**DAC 25/07/23 – 21 PARNELL PLACE NEWCASTLE EAST –
DA2022/00705 – MIXED USE - ALTERATIONS AND ADDITIONS TO
EXISTING HOTEL OR MOTEL ACCOMMODATION (NEWCASTLE
BEACH HOTEL), ANCILLARY FOOD AND DRINK PREMISES AND
COMMERCIAL USE (ANCILLARY HOTEL SPA) AND DUAL
OCCUPANCY (ATTACHED 2 X DWELLINGS)**

PARNELL PLACE

21 Parnell Place, Newcastle East, NSW 2300
LOT 1 /DP815595

3. 3rd FLOOR GFA SCALE 1:200

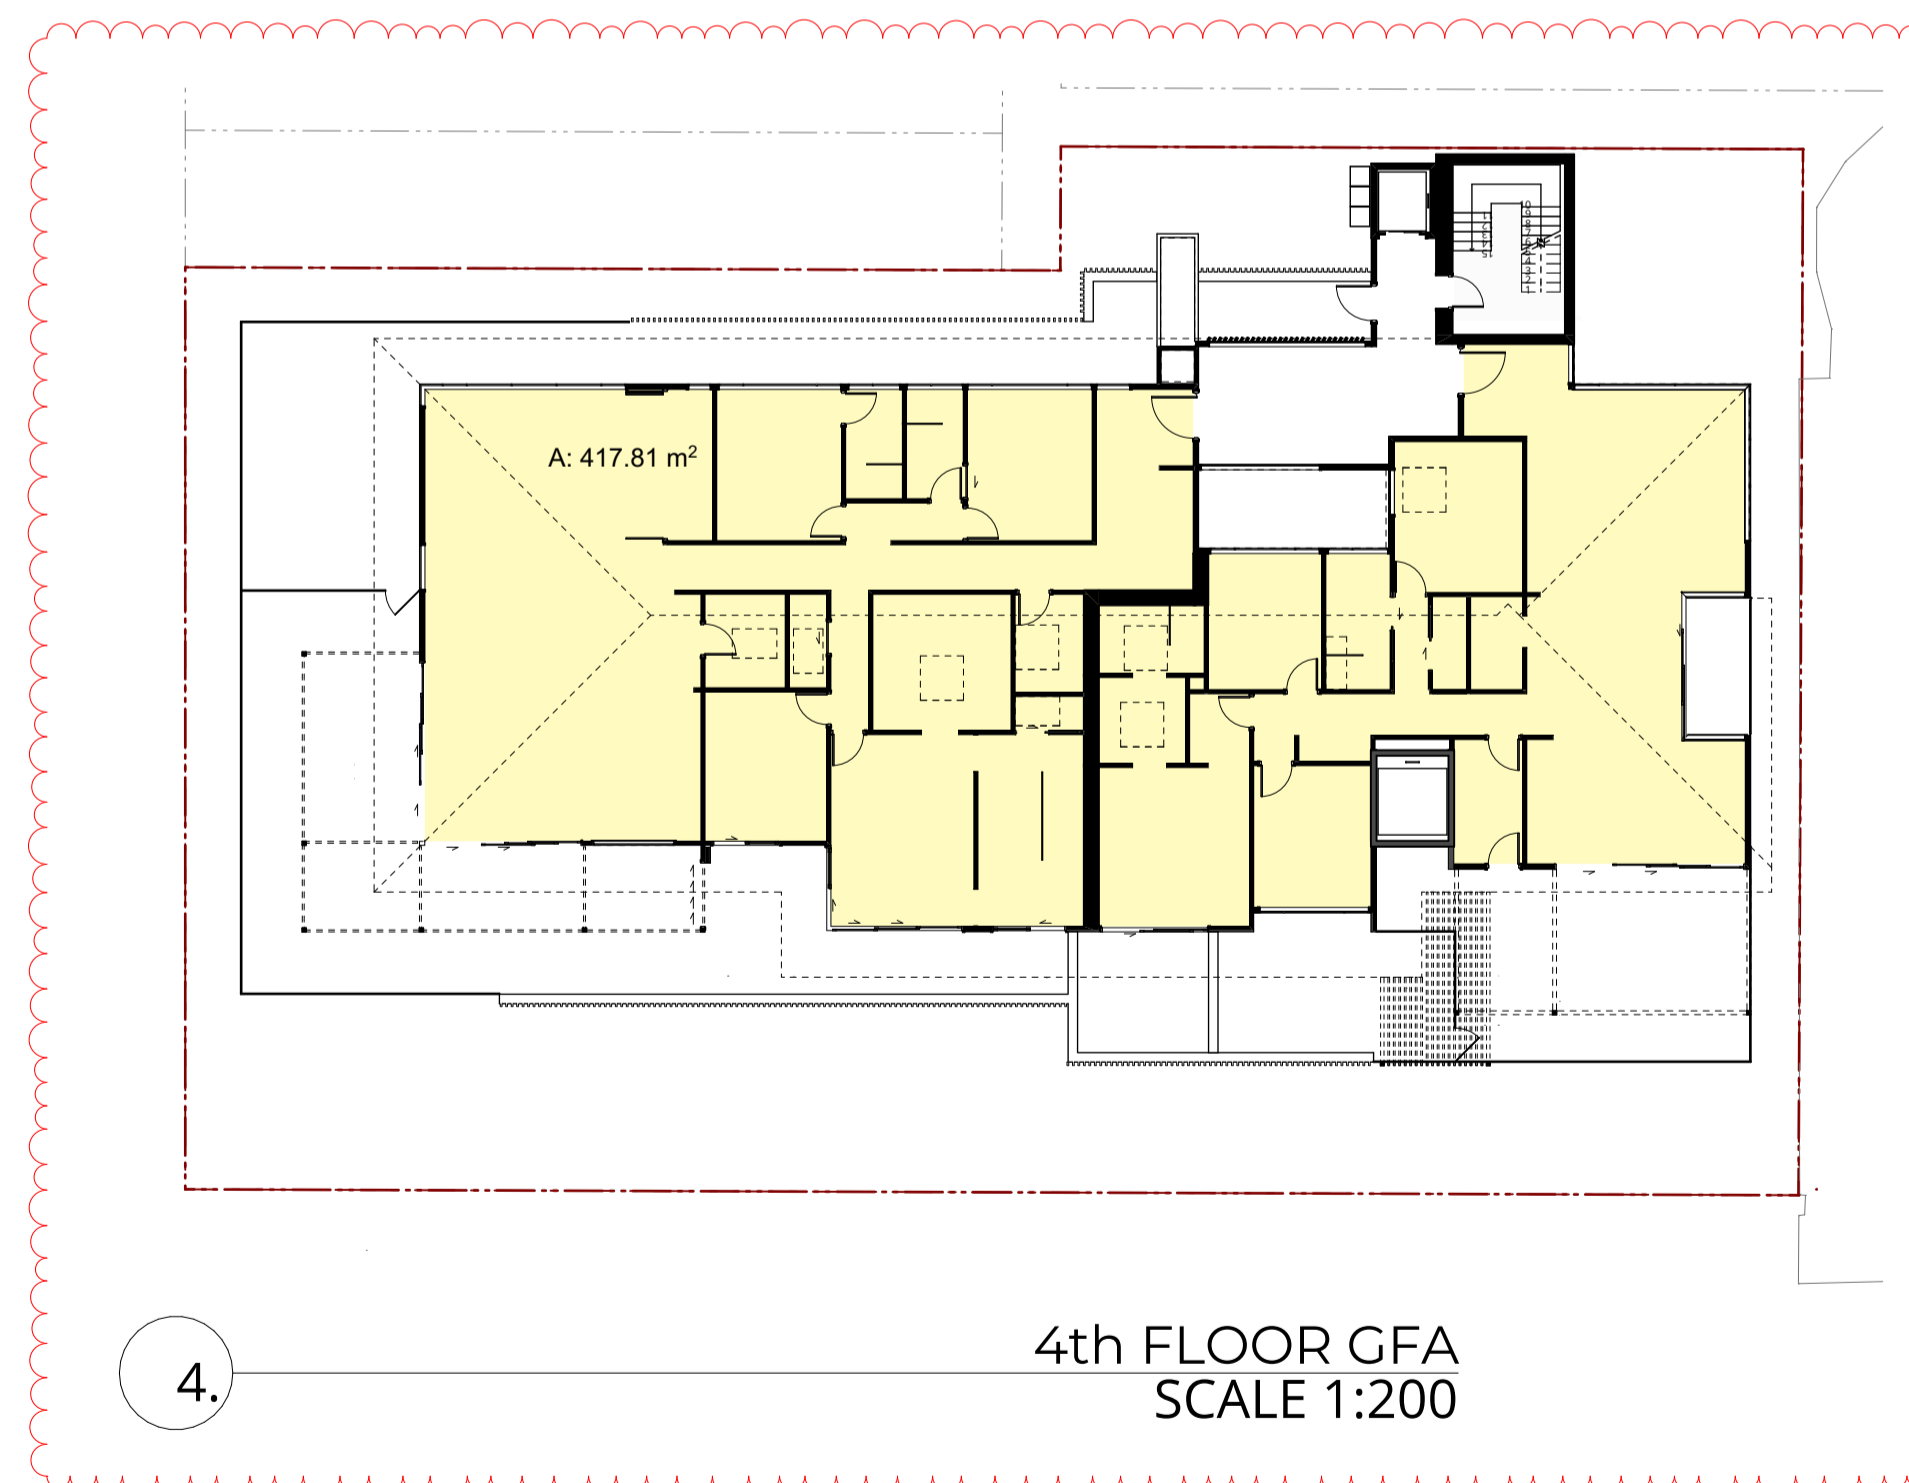
- PENTHOUSE 2 SETBACK FROM SOUTH EAST CORNER BY 1200MM

- BIN AND KEG ROOMS REWORKED TO PROVIDE SPACE FOR MORE BINS
